HYDROCARBON ABATEMENT PROPOSAL
NORTH FUEL TANK AREA
TINKER AIR FORCE BASE
BUILDING 3001

Clarification Sheet For Nova Engineering

**"Hydrocarbon Abatement Proposal
North Fuel Tank Area
Tinker Air Force Base
Building 3001".**

FIGURE 2

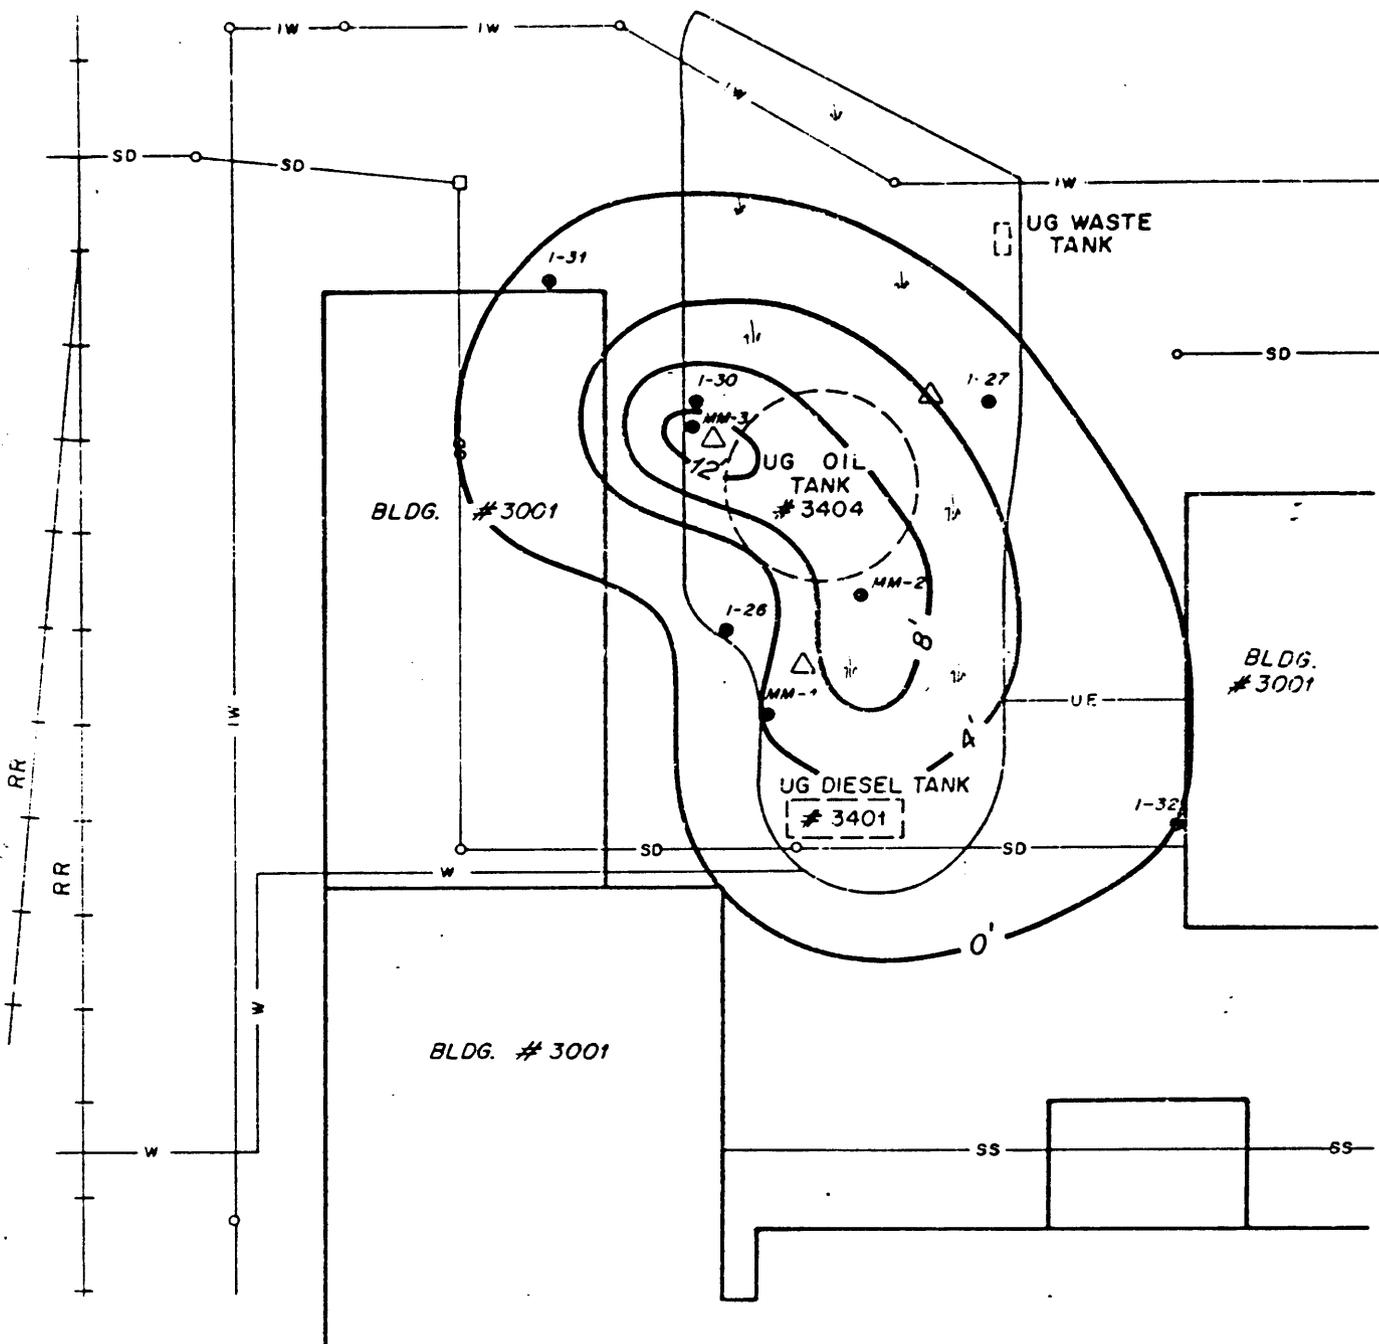
E. Phase separated recovery well locations are given on Figure 2 page 5, but are not referenced in the report.

FIGURE 3

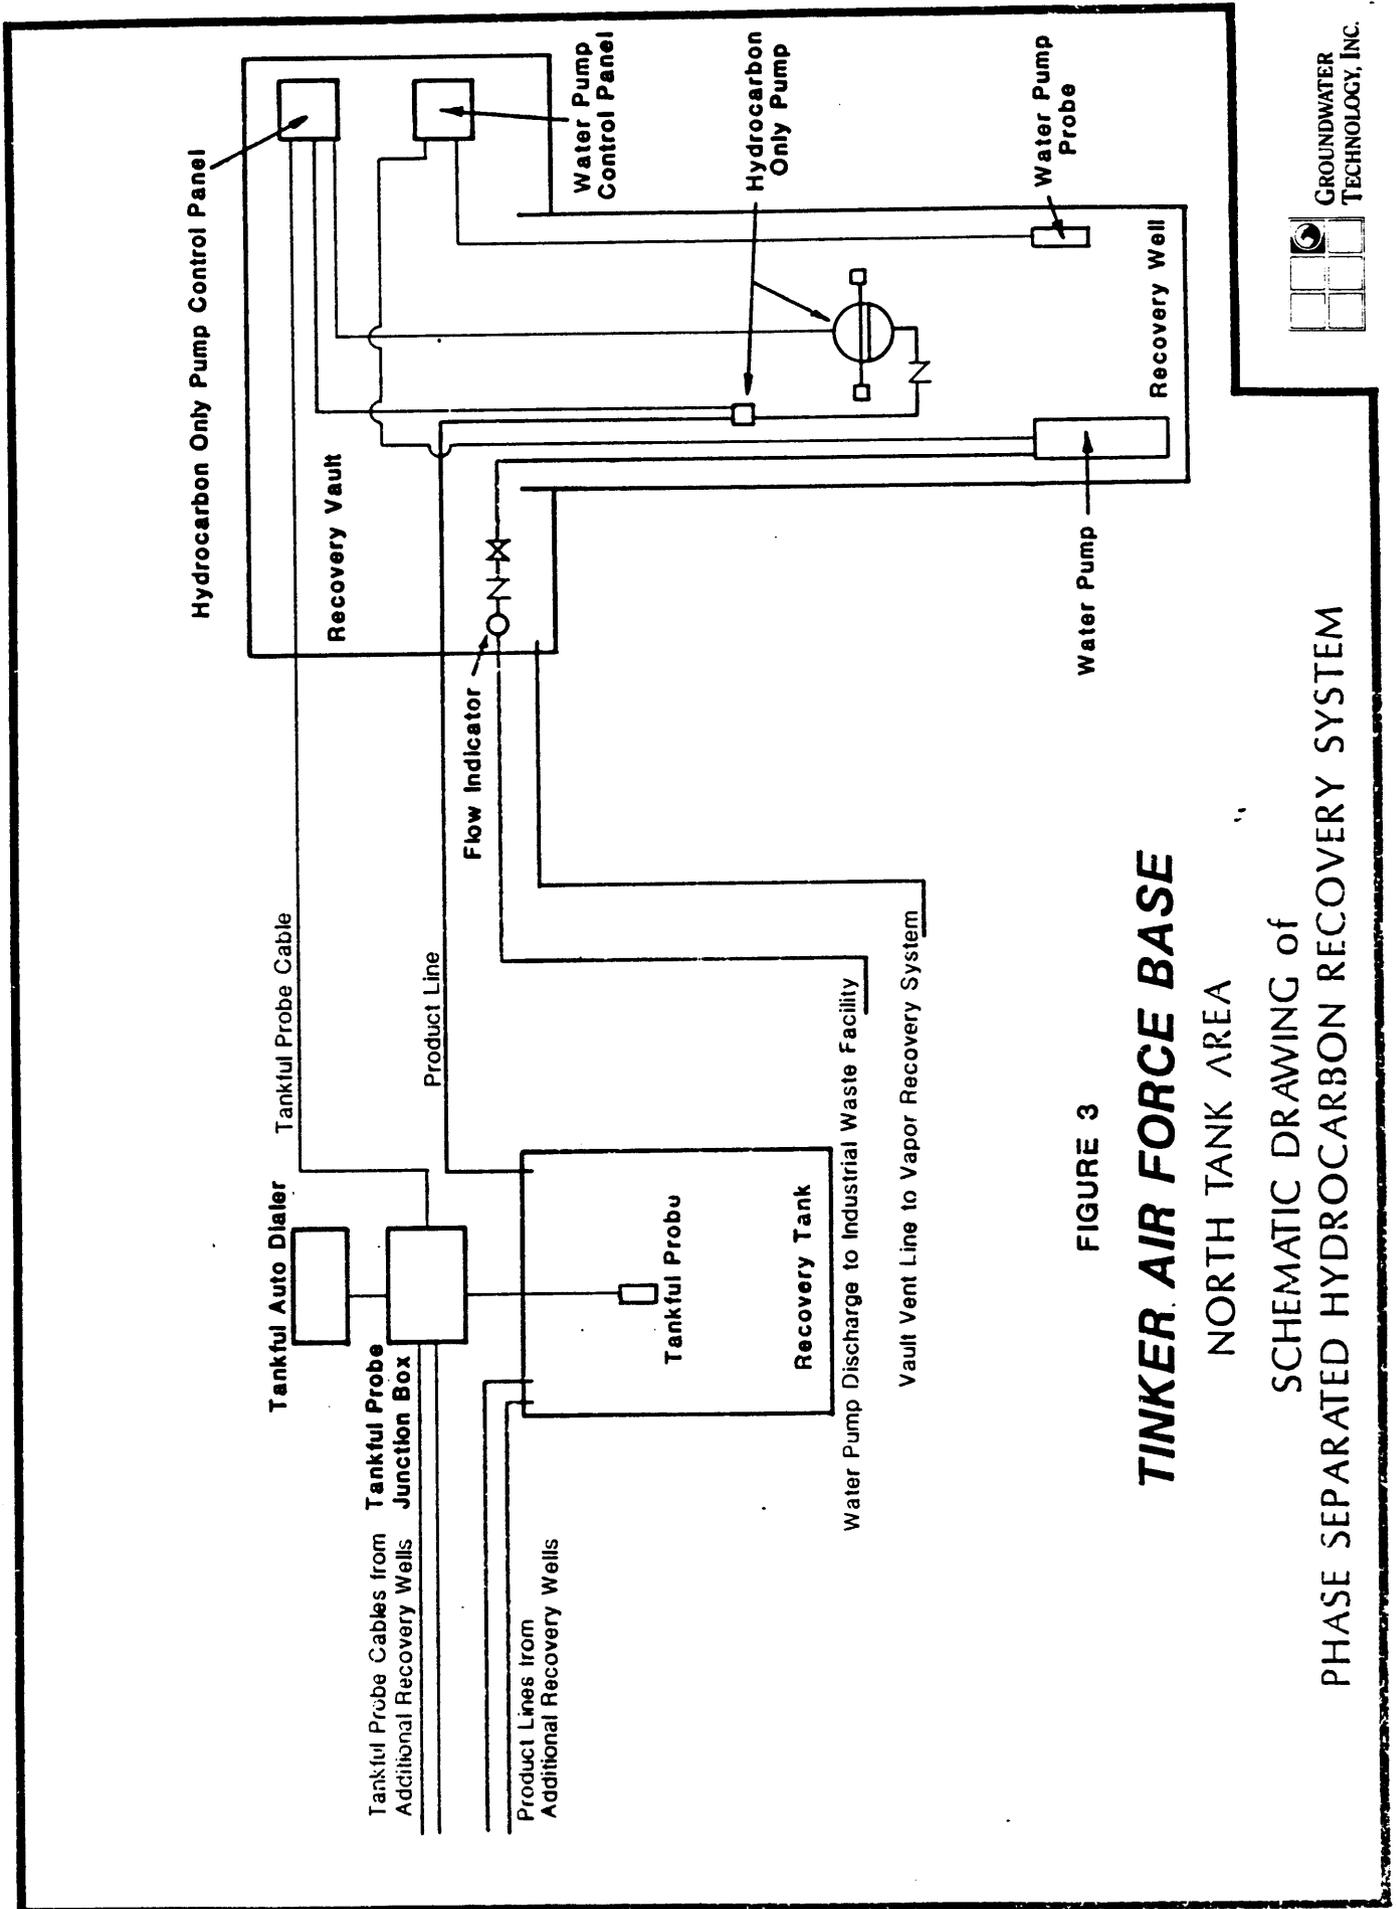
A. The system should be designed so that it can accommodate groundwater depression pumps and flowlines, but only the product pumps and flowlines are to be installed under this contract.

B. The vent lines from the vaults should discharge to the atmosphere rather than to a carbon adsorption unit.

C. Mechanical loading requirements for the vaults should be coordinated with Base Civil Engineering.

FIGURE 4

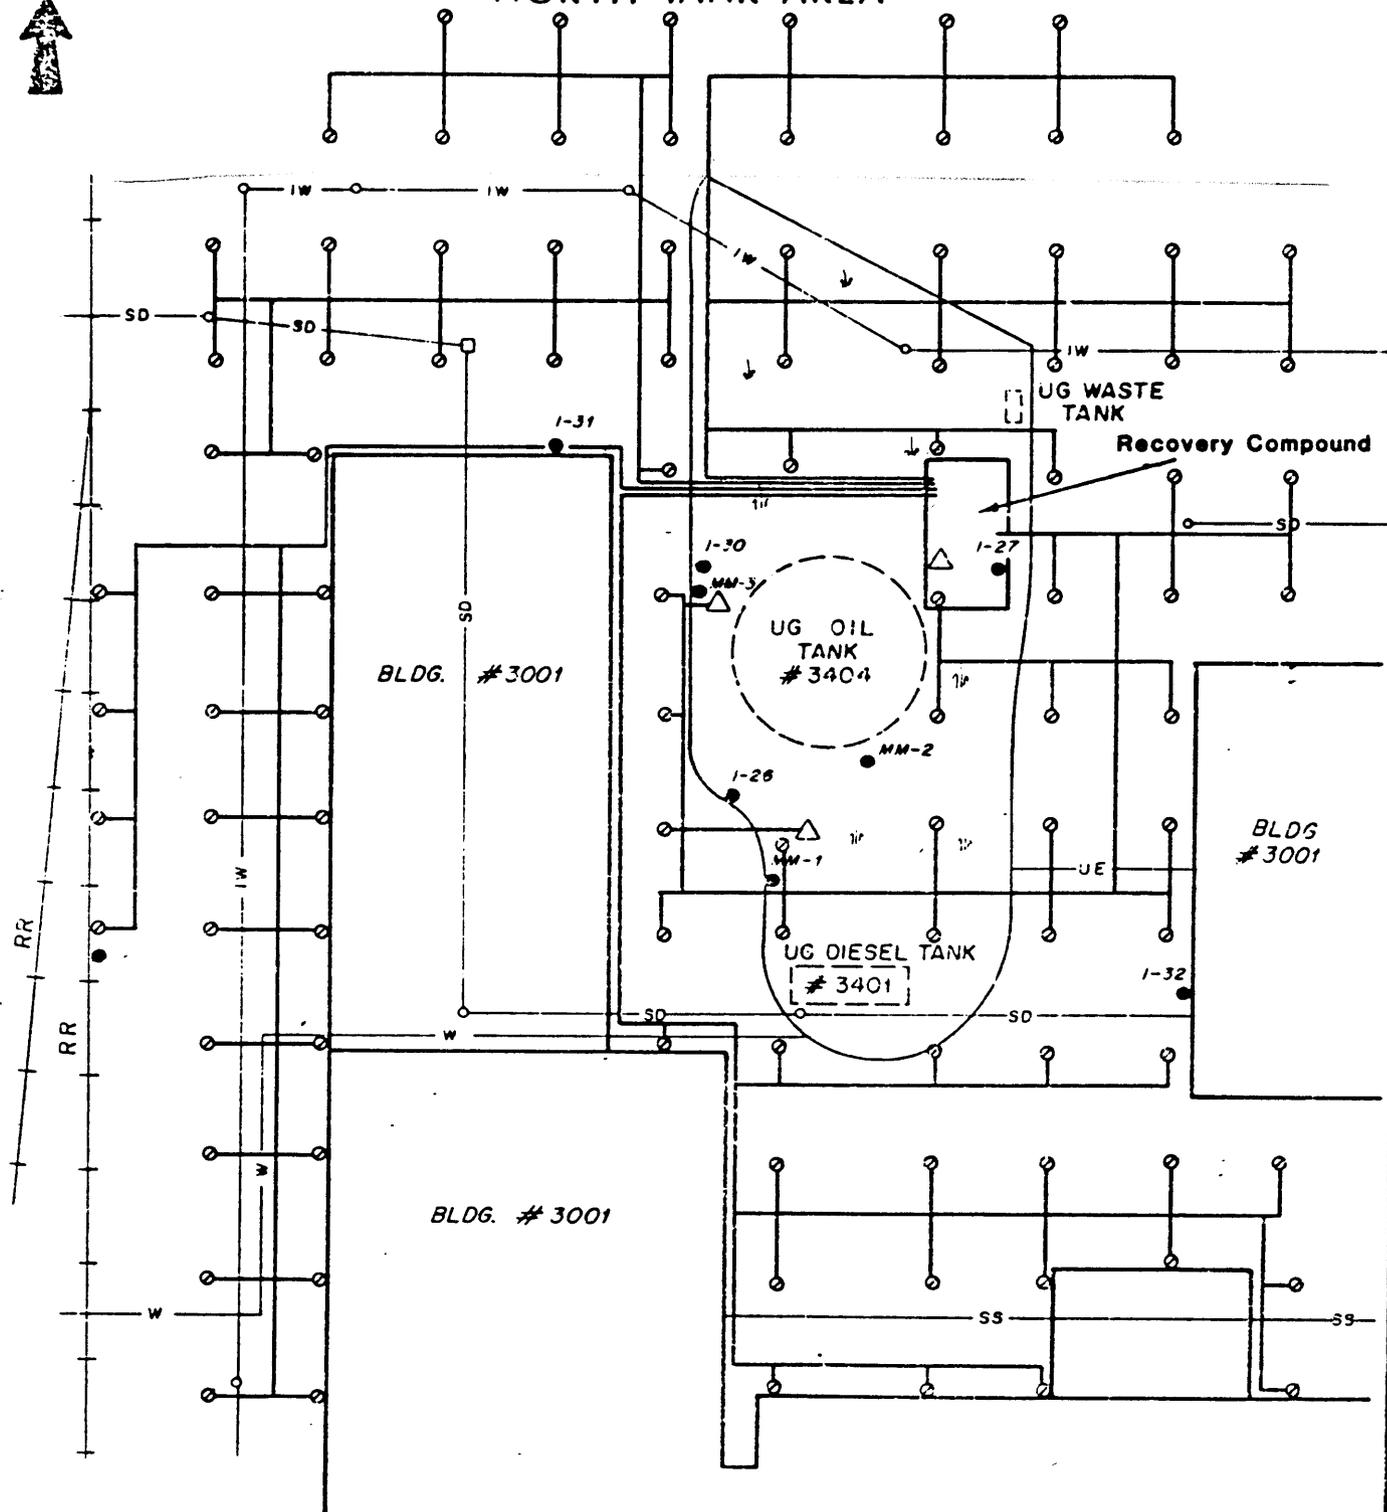
A. The installation of this system as described in section 7 should be include in the construction contract documents.

B. Vapors collected by this system should be vented to the atmosphere instead of to a carbons adsorption unit.

FIGURE 6

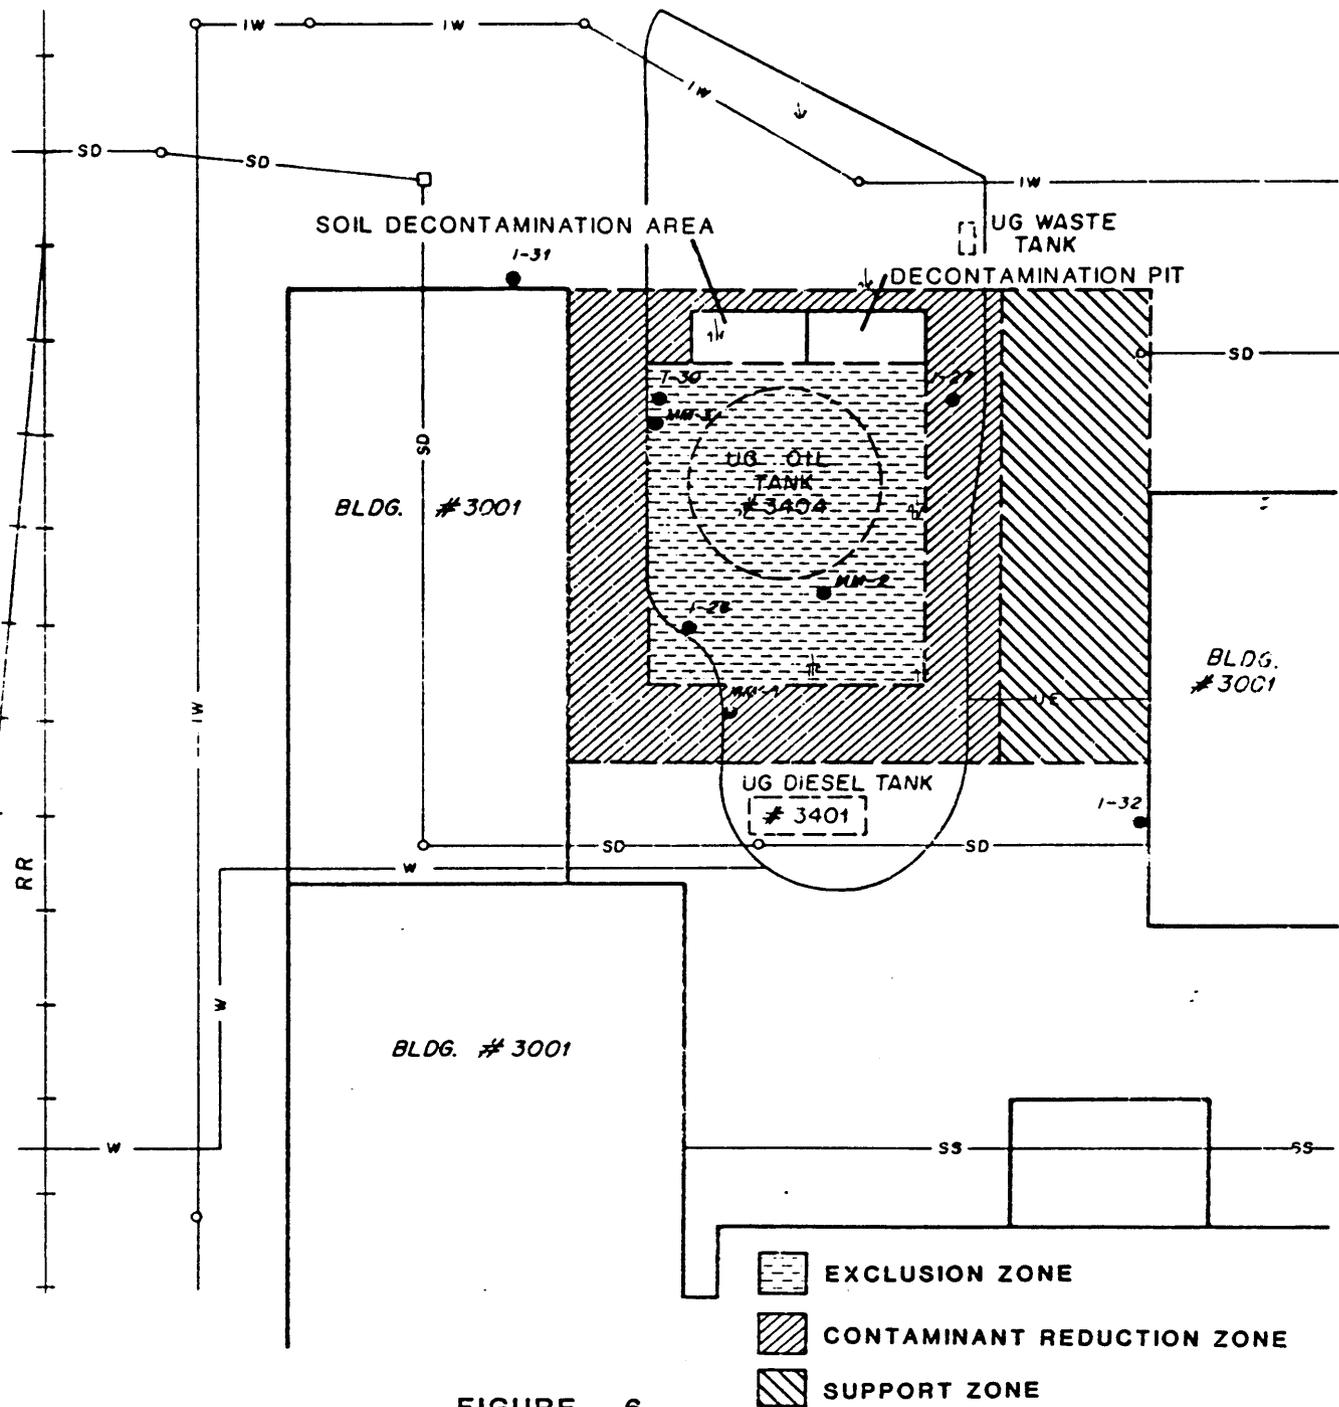
C. The worker protection requirements and work zone designations for the installation of this system will be clarified.

FIGURE 7

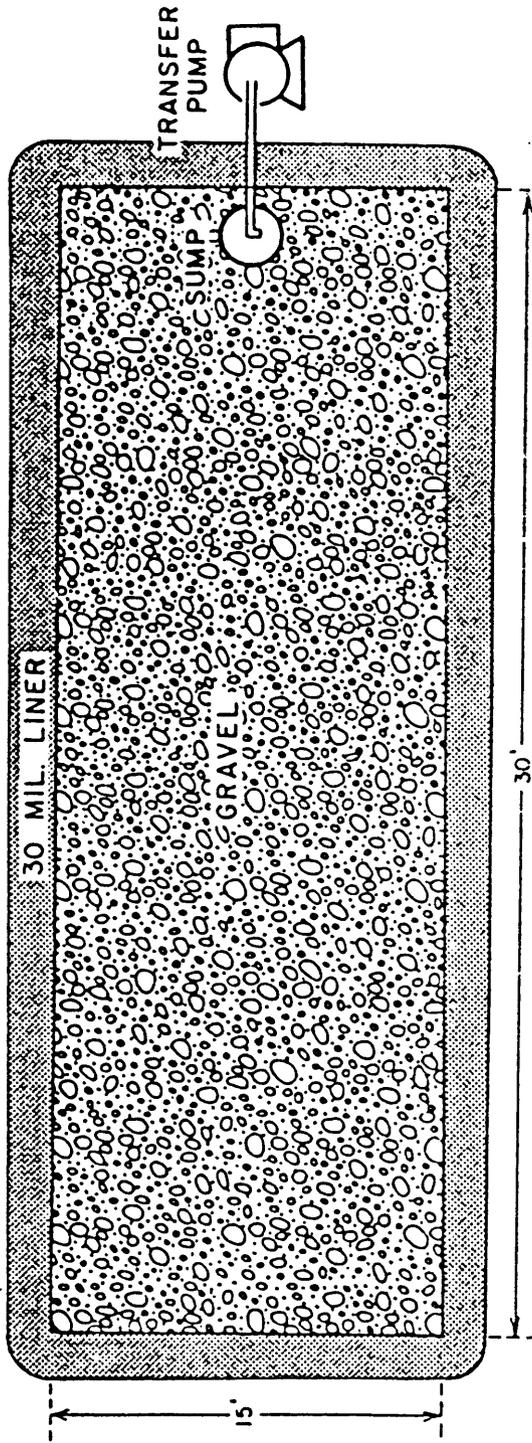
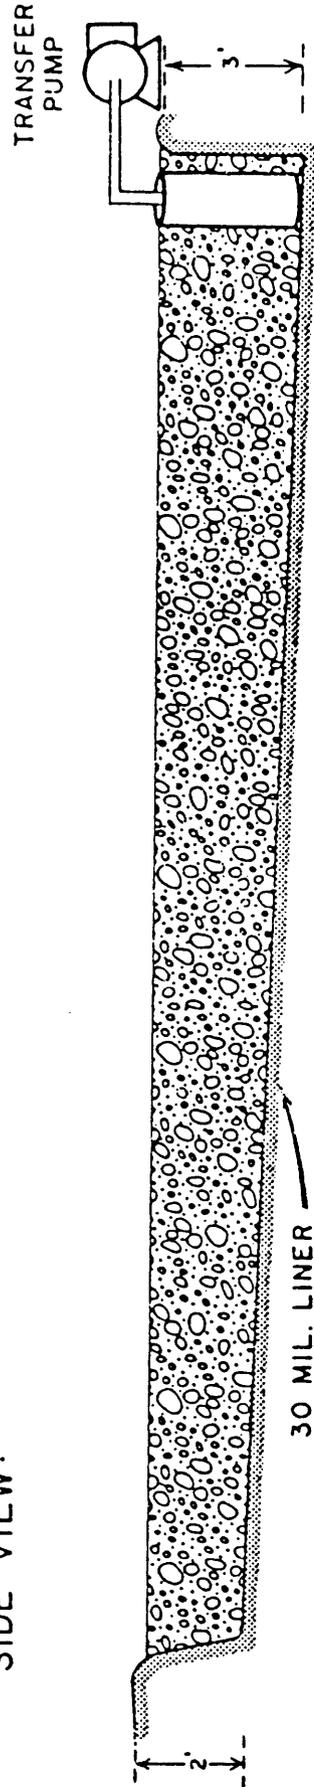
A. The decontamination sump described on page 17 will not be required. The handling requirements for well cuttings will be revised such that no polyethylene liners will be required.
